RAVENSWORTH OPERATIONS PROJECT

Narama West Open Cut Modification (MP 09_0176 Mod 1)

Figure 3: Proposed Narama West Modification

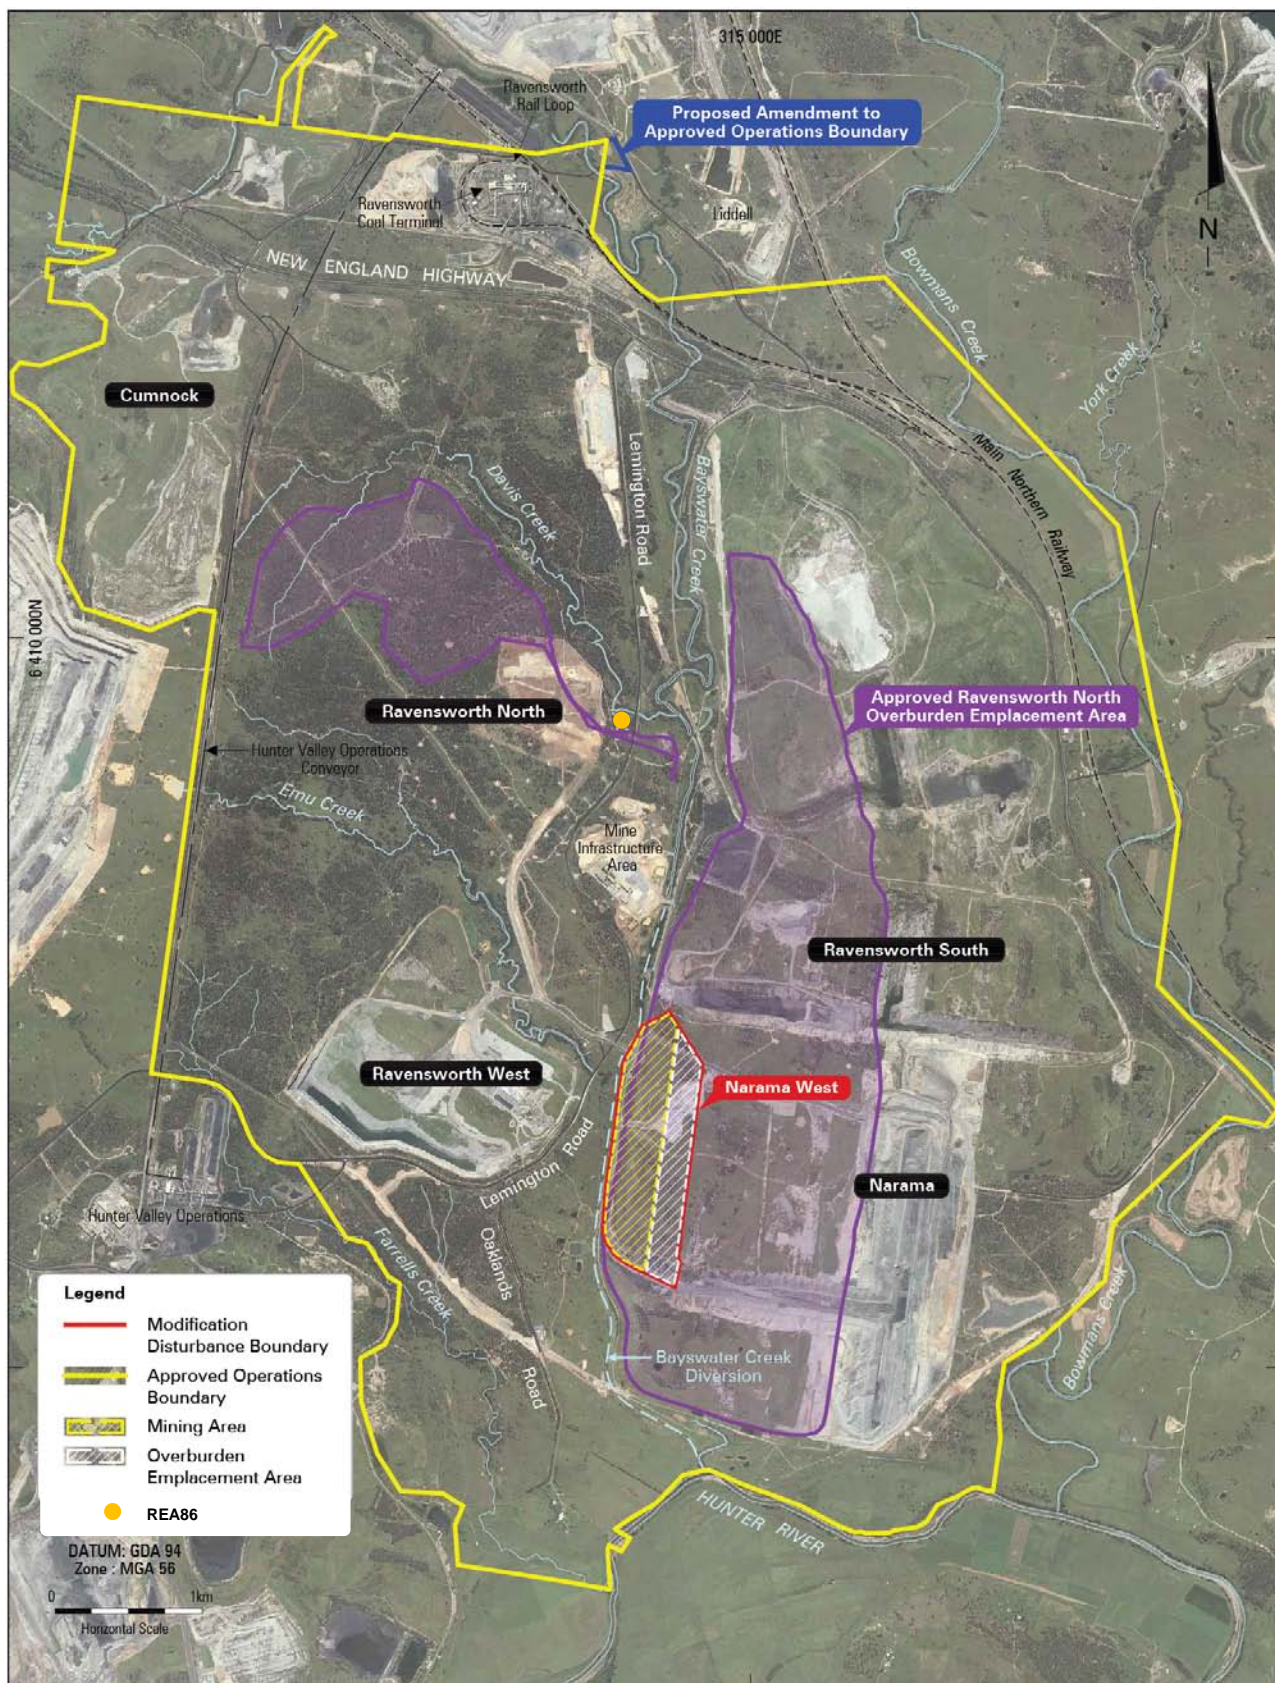
The EA for the Ravensworth Operations Project identified an Aboriginal grinding groove site (REA86) located approximately 250m north of the Ravensworth North Pit (see Figure 3). REA86 was assessed as being highly significant in terms of culture and archaeology and, as such, Xstrata committed to limit the blast vibration criterion at REA86 to 30 millimetres per second (mm/s) to manage potential blasting impacts.

Accordingly, in the proposed modification Xstrata proposes to incrementally increase the blast vibration criteria from 30 mm/s to a maximum of 175 mm/s.

The Department is satisfied that the geotechnical assessment indicates that REA86 is unlikely to be adversely affected by the proposed higher ground vibration limits. To ensure the protection of the grinding grooves site, the Department has recommended conditions requiring Xstrata to comply with each incremental ground vibration limit, up to a maximum of 175 mm/s. In applying for approval from the Director-General for an increase in the incremental limit (i.e. from 60 mm/s, to 120 mm/s, and then from 120 mm/s to 175 mm/s), Xstrata would be required to provide a report prepared by a suitably qualified expert, in consultation with OEH and relevant Aboriginal groups, demonstrating that blasting at these limits is not having any discernible impact on the axe grinding groove site.

Figure 5: Proposed Amendment to Project Boundary

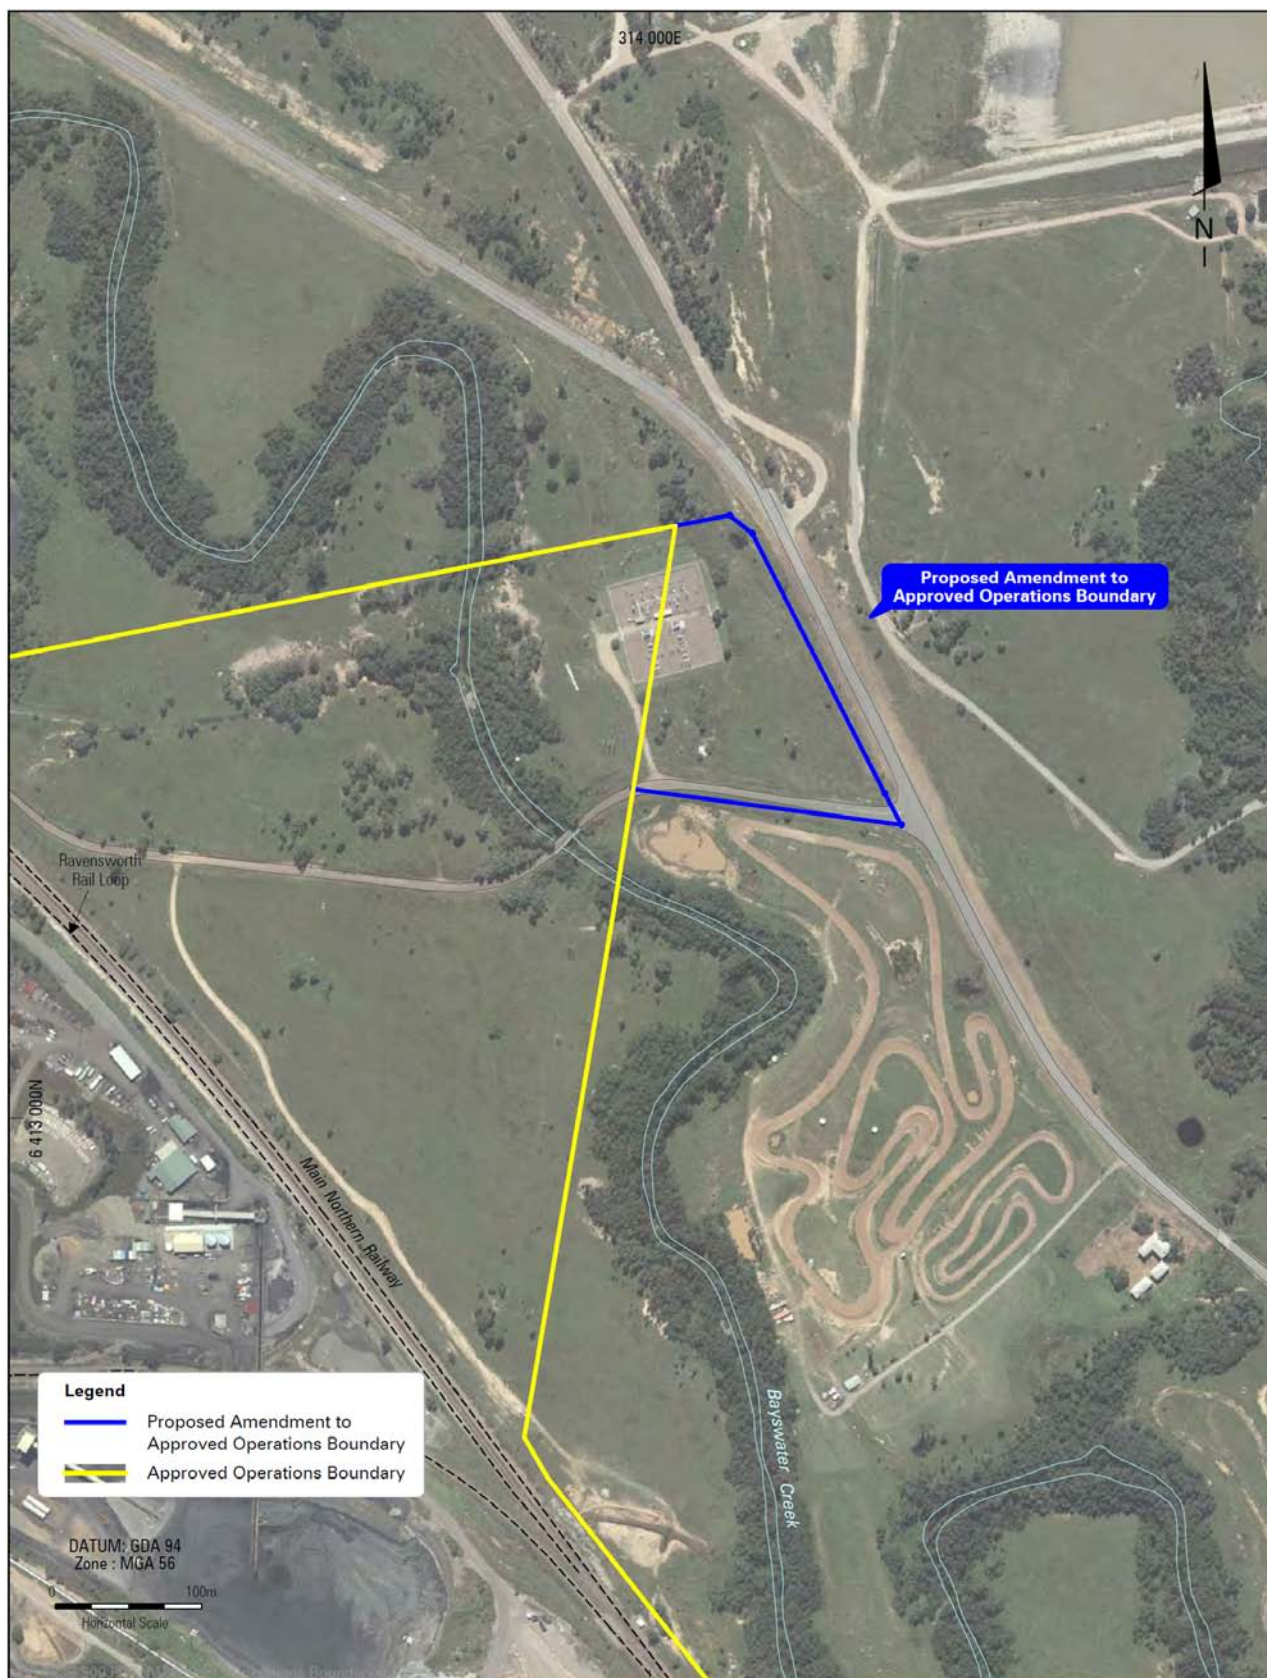
Issue	Consideration	Recommendation
<i>Amendment to Approved Project Boundary</i>	<ul style="list-style-type: none"> Xstrata proposes to amend the approved project boundary to include the existing Newdell substation (see Figure 5), which is located on land consistent with the approved schedule of lands. The Department notes that: <ul style="list-style-type: none"> Xstrata manages and relies upon the Newdell substation for electricity to supply its current operations; the approved operations boundary currently cuts through the middle of the Newdell substation; and the proposed boundary amendment is purely administrative in nature. Consequently, the Department is satisfied that the proposed boundary amendment would have no operational or environmental consequences and has updated the conditions of approval accordingly. 	The Department has amended the conditions to include the realigned project boundary.
